PLANNING AND ENVIRONMENT COMMITTEE**10 MAY 2023****2**

DEVELOPMENT PERMIT FOR RECONFIGURING A LOT (2 LOTS INTO 68 LOTS, NEW ROAD AND BALANCE LAND) – 101R-103R COOPER ROAD AND 900L WILDERNESS WAY, MOUNT PETER – DIVISION 1

PROPOSAL: DEVELOPMENT PERMIT FOR RECONFIGURING A LOT (2 LOTS INTO 68 LOTS, NEW ROAD AND BALANCE LAND)

PROJECT: Q204085-07-CI-SK04 - COOPER ROAD CIVIL WORKS INTERIM AND ULTIMATE WORKS PLAN - SHEET 4
 DATE: 22/11/2022
 DRAWING NO: Q204085-07-CI-SK04

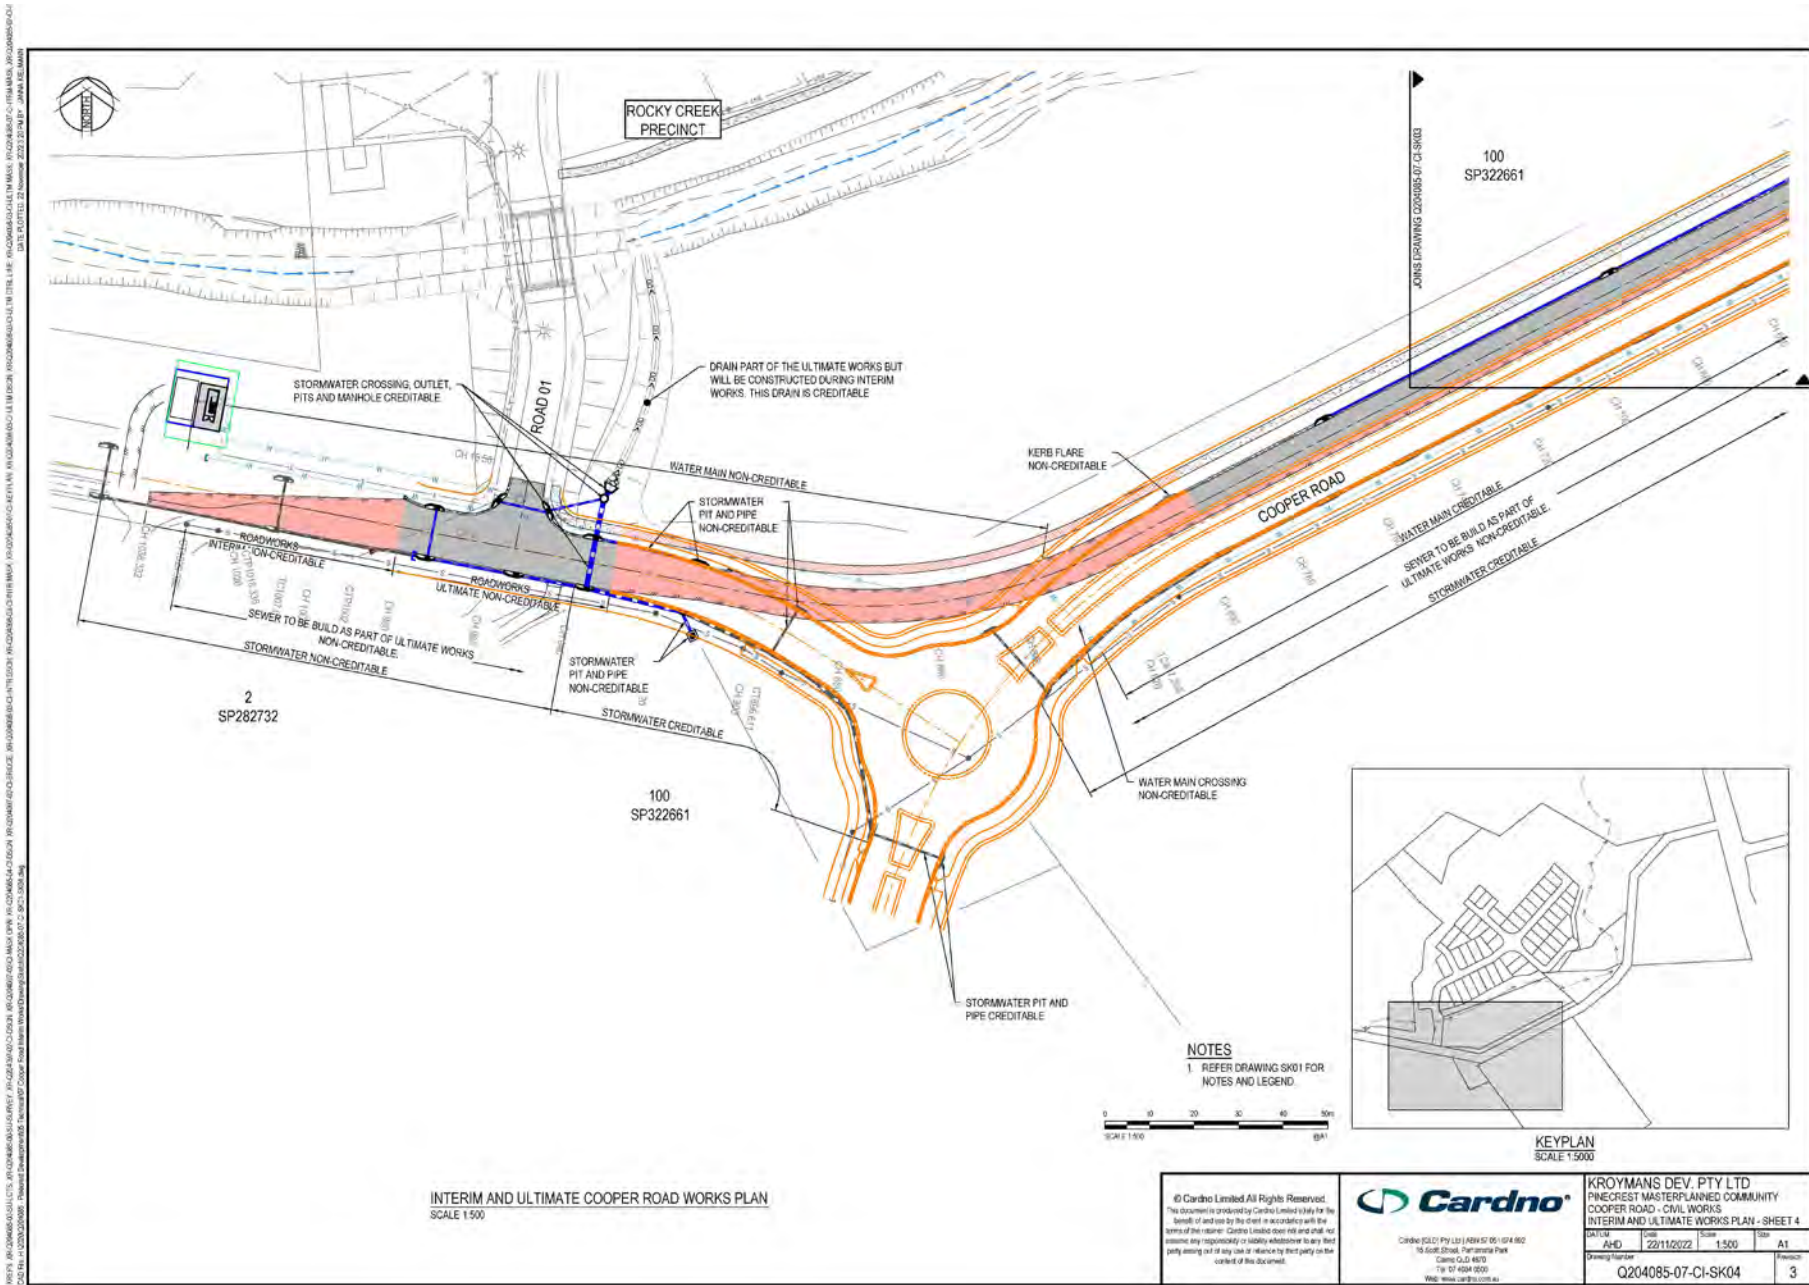
18. Prior to an application for Operational Works for Stage 3, prepare and submit to Council for approval RPEQ (traffic) certified preliminary design plans for the following intersections under Condition 20:
 - a. Intersection (roundabout) shown on Drawing Number Q204085-07-CI-SK02, Rev 3, Cooper Road – Civil Works Interim and Ultimate Works Plan – Sheet 2 and dated 22/11/2022; and
 - b. Intersection (roundabout) shown on Drawing Number Q204085-07-CI-SK04, Rev 3, Cooper Road – Civil Works Interim and Ultimate Works Plan – Sheet 4 and dated 22/11/2022.

- b. Intersection (roundabout) shown on Drawing Number Q204085-07-CI-SK04, Rev 3, Cooper Road – Civil Works Interim and Ultimate Works Plan – Sheet 4 and dated 22/11/2022.
